STANDARD REQUIREMENTS FOR DRAINAGE PLANS

DRAINAGE PLAN

LOT 1
BLOCK 9
FERNWOOD [illegible]
ALBUQUERQUE, NEW MEXICO

LOT 7
BLOCK 8
BRENTWOOD HILLS
ALBUQUERQUE, NEW MEXICO

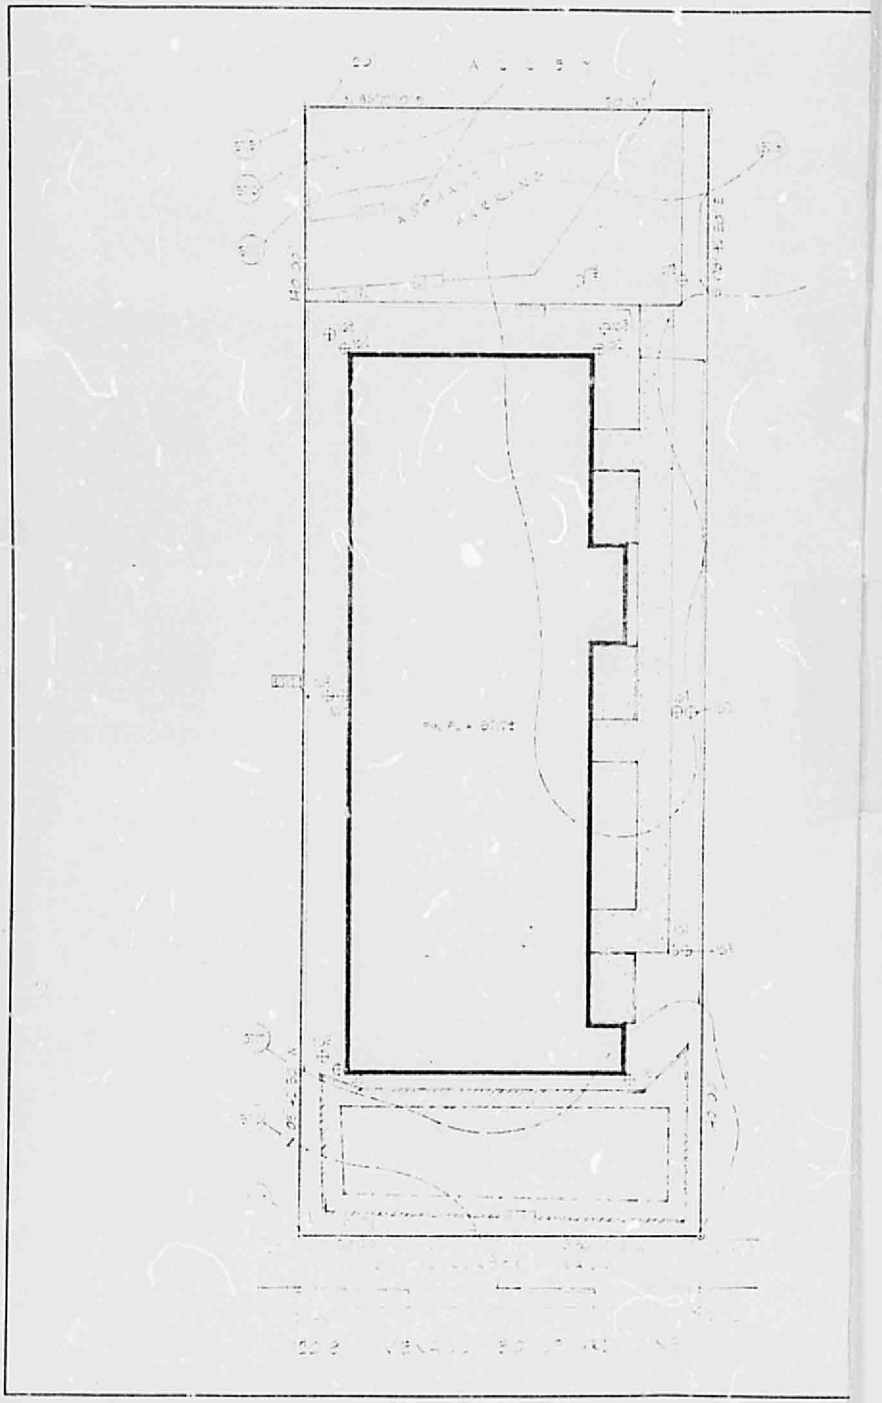
NO Is property located in the flood plain? NZZ

NO Is property adjacent to a natural or artificial water course?

NO YES Per topo map, does property intercept other drainage upstream?

NO Does site plan show contours before development (extending a minimum of 25 ft. beyond property lines)?

YES Is there continuity between proposed new contours and old contours offsite?

NO Is elevation of property line at least 0.3 ft. above top of curb?
BECAUSE CURB + GUTTER EXISTING

YES Is ponding volume adequate (supply detailed computation)?

YES Can pond volume be computed and verified?
